**CITY OF HANOVER
PLANNING COMMISSION MEETING
JUNE 25, 2018
7 PM
AGENDA**

**CITY OF HANOVER
PLANNING COMMISSION MEETING
MAY 23, 2018
DRAFT MINUTES**

Subj: Planning Review Comments – Crow River Heights West 4th Addition
Final Plat and Plans dated May 24, 2018

As requested, we have reviewed the revised Crow River Heights West future additions preliminary plat documents as prepared by Loucks, dated May 24, 2018, as well as Crow River Heights West 4th Addition Final Plat documents as prepared by Loucks, dated May 24, 2018 and we offer the following comments:

P:\05_25_2018_11:54 AM W\2018\16101A\CADD\DATA\CADD\DWG\Sheet Final\C3-2 GRADING PLAN

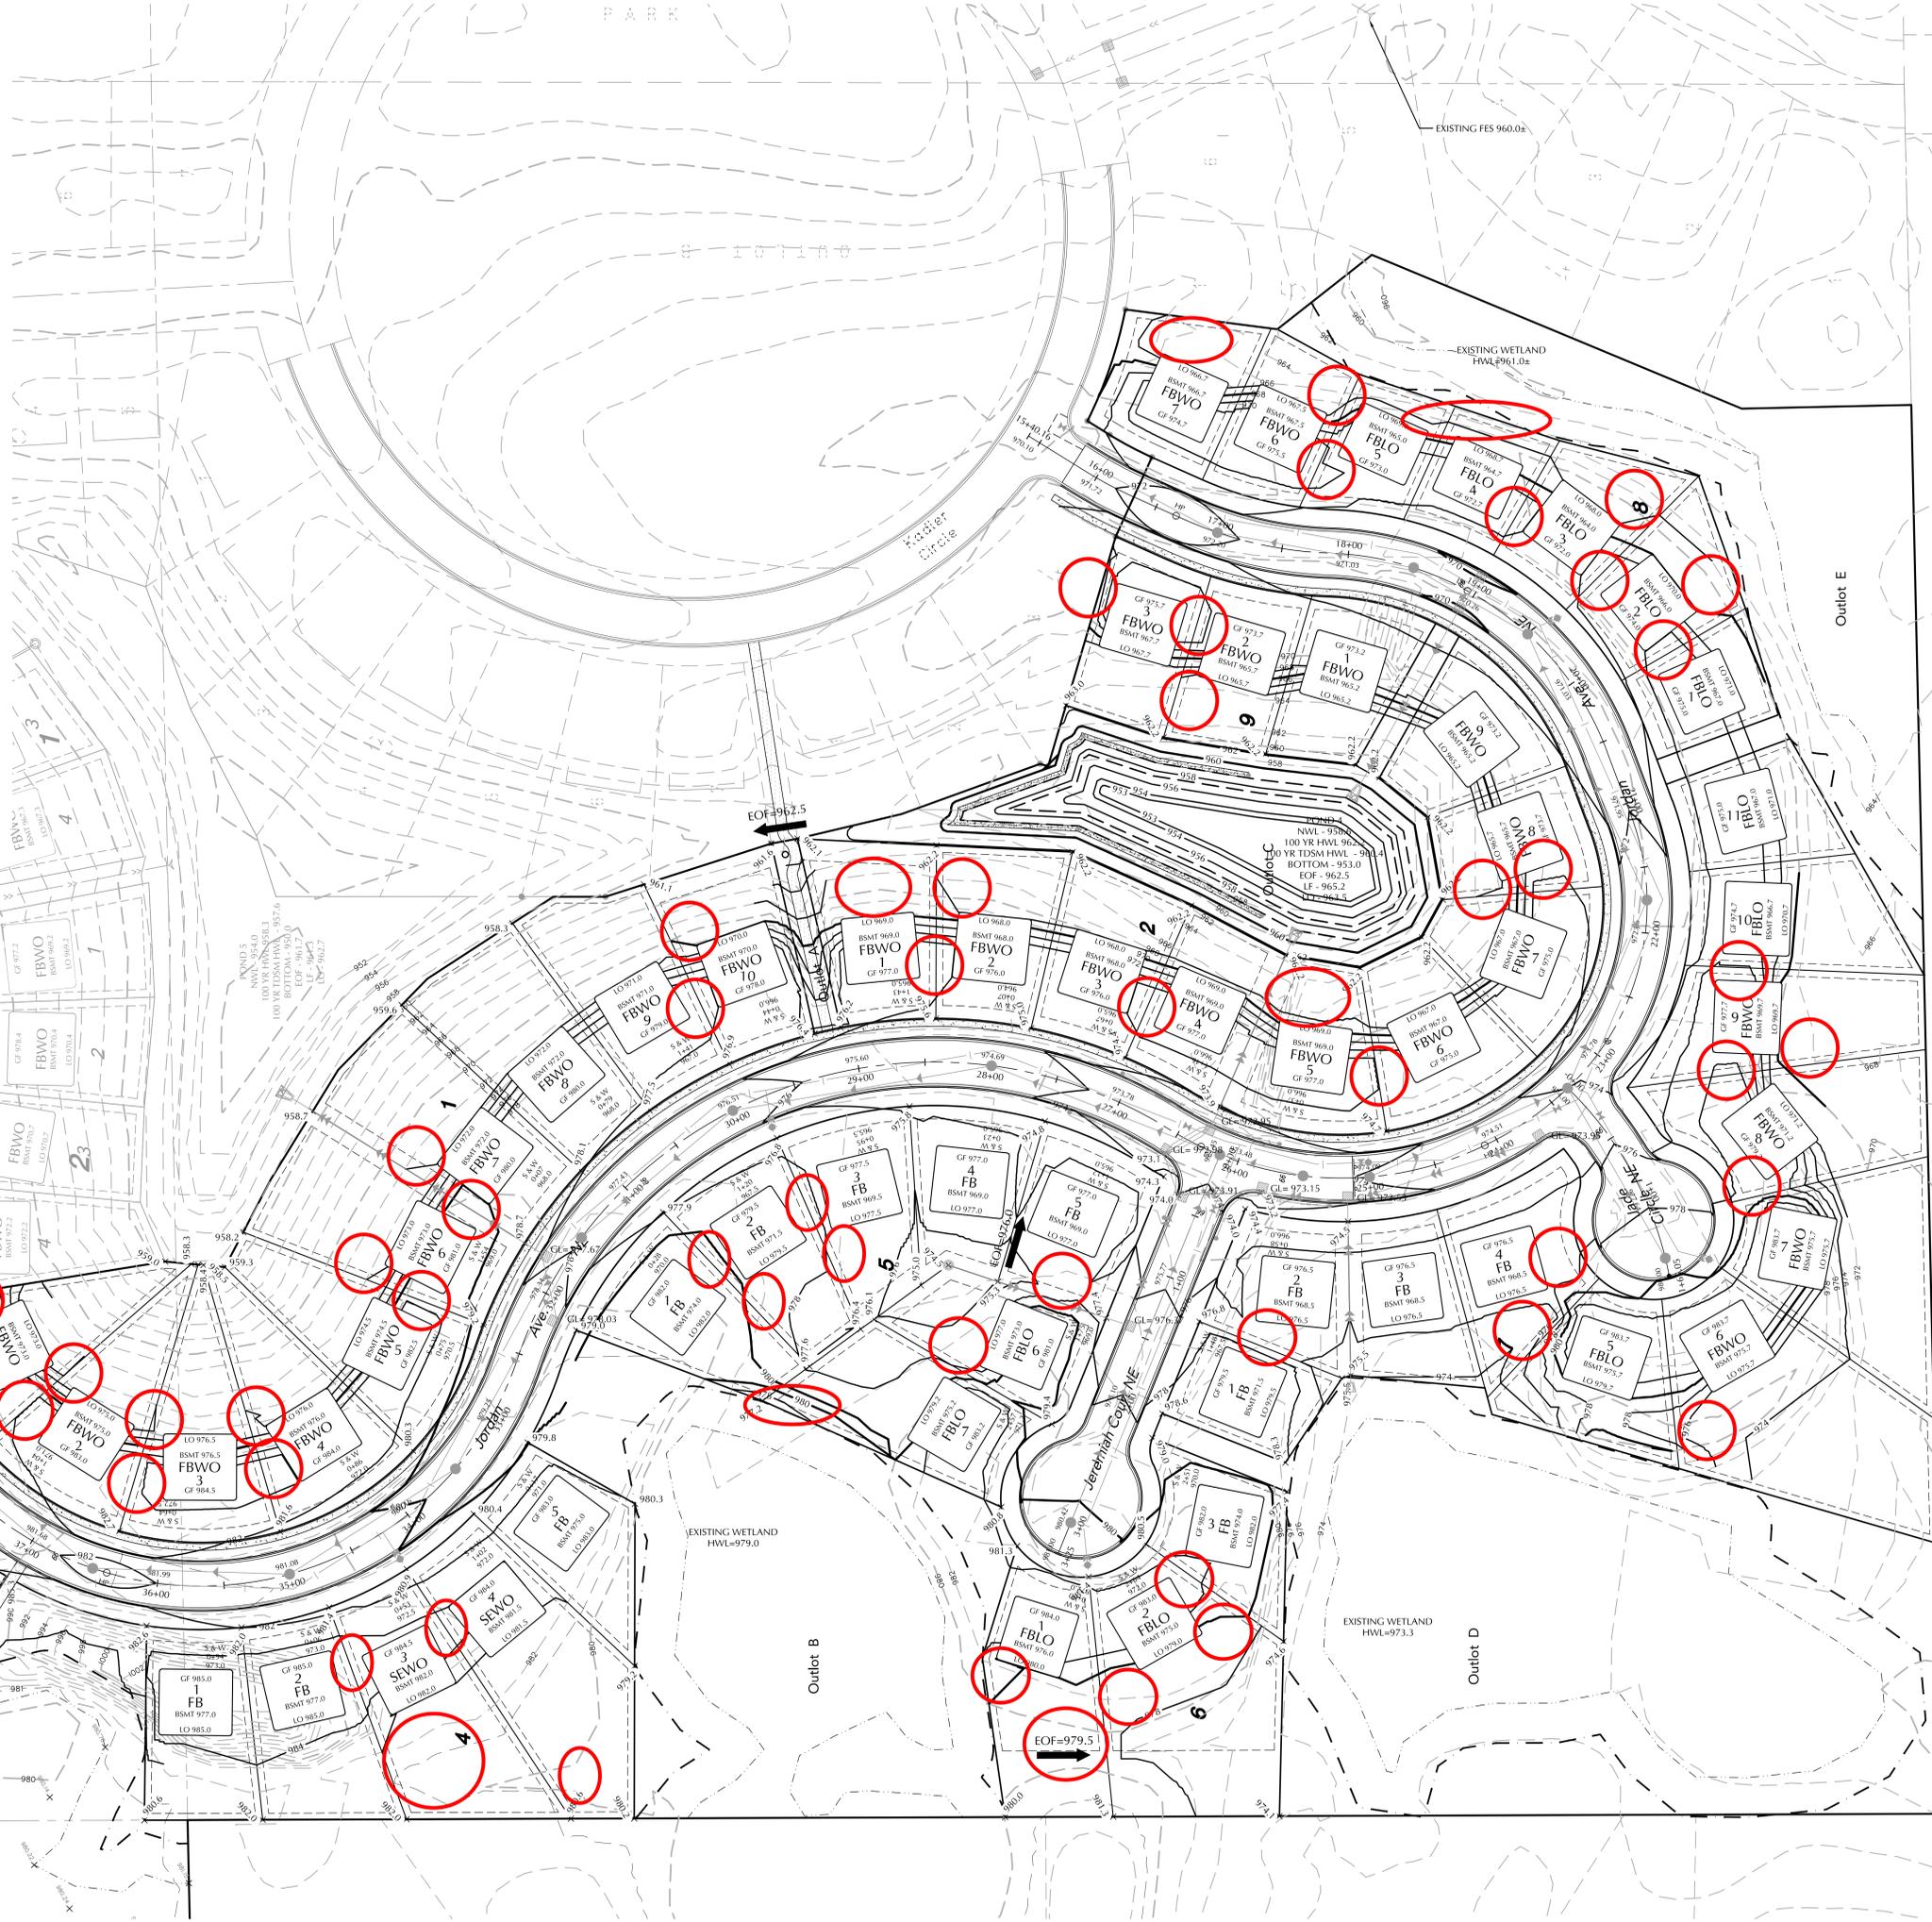
Christenson wanted to know if the grading by 10th Street is going to as severe as it appears on the plan. Messner looked at the property on the map and said drainage should be maintained. McLouth said that the berm created (which appears as severe grading) will be used to keep the water from Ylitalo's property.
